RE: Water retention storage design
Reference to Grading and Drainage plan (Shade Group Mar 8th, 2023)
Reference to Fire Flow Calculation (TTF Engineering Feb 27th, 2023)
8005 Jock Trail
Part Lot 9, Concession 3
Geographic Township of Goulbourn
City of Ottawa
Owner / Designer (s): Tom and Janet Moul

DOCUMENT REVIEW

RE: Water retention storage design

Reviewed by: Lynne Melvin, President of Clean Water Pro

Proposed / Existing fire retention storage.

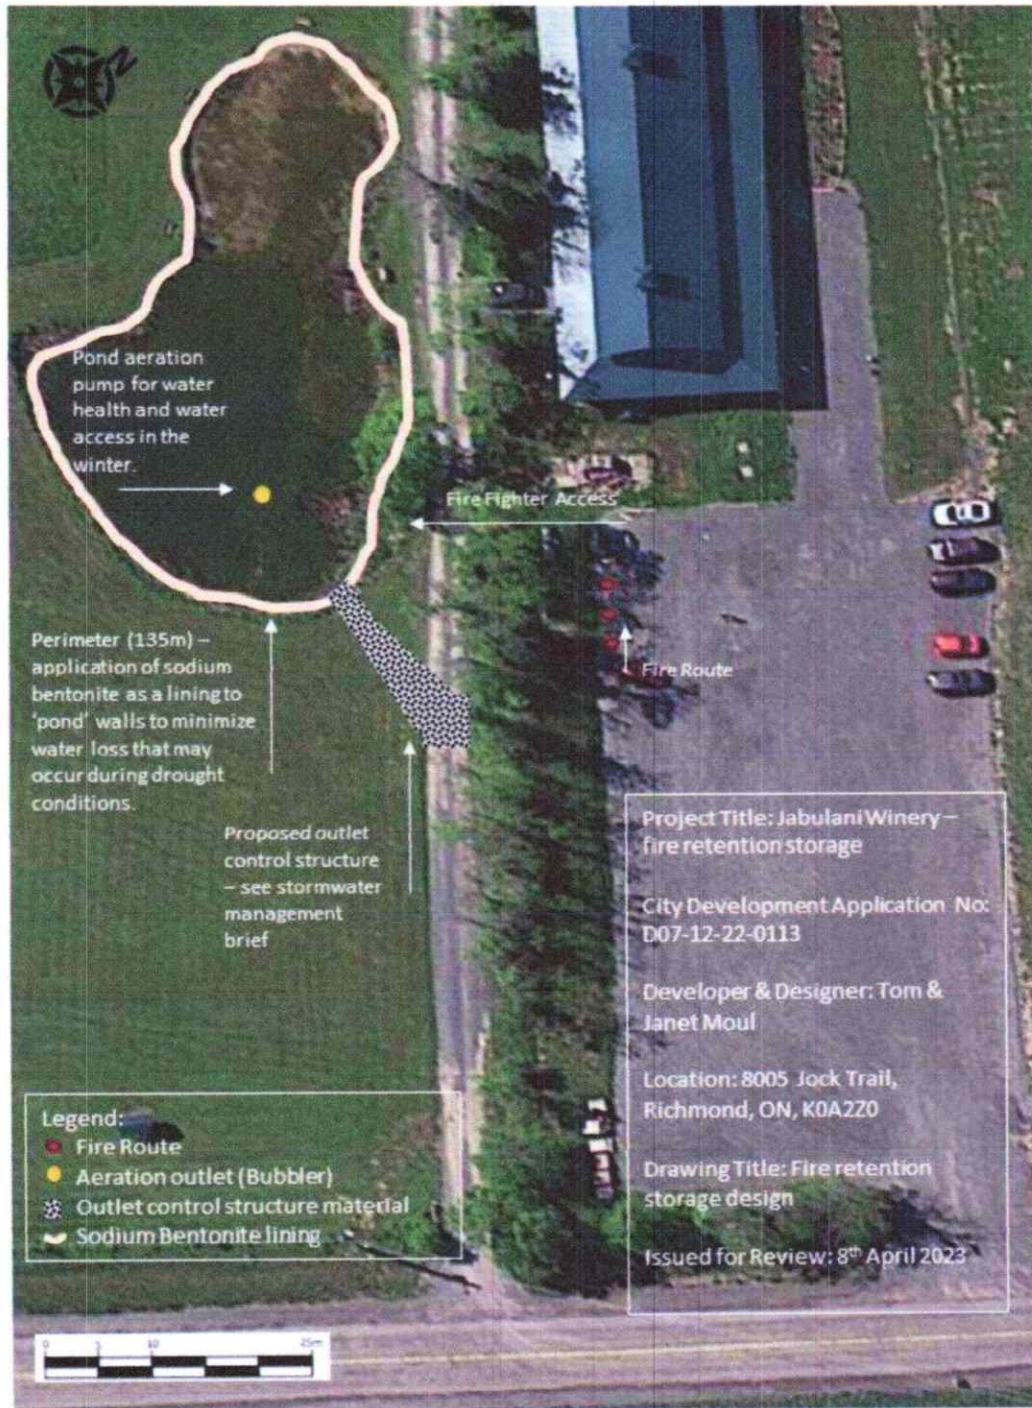
- Bentonite is a good choice to seal the water body
- The owner has access to water to top up the water body during periods of evaporation to maintain an adequate level.

- Note: the retention pond should be topped up to the maximum amount of water prior to freeze up in the fall.
- Good access is planned for fire fighter's access.

- Aeration system recommendations:
 - 4 diffuser plate shallow water system to ensure adequate turn over and dissolved oxygen
 - Diffuser plates are to be distributed across the water body in deepest spots possible

- Water should stay open during the winter months where the aeration plates are situated.
 - Note: In winter, flow to the plate(s) should be slowed to reduce risk of turning water too quickly due to the shallow nature of the water body

- To keep the water healthy, we suggest a shallow water aeration system with 4 diffuser plates spread out across the water body.
- Aeration will promote healthy water with increased dissolved oxygen with will promote digestion of organics and nutrients such as ammonia and nitrogen.
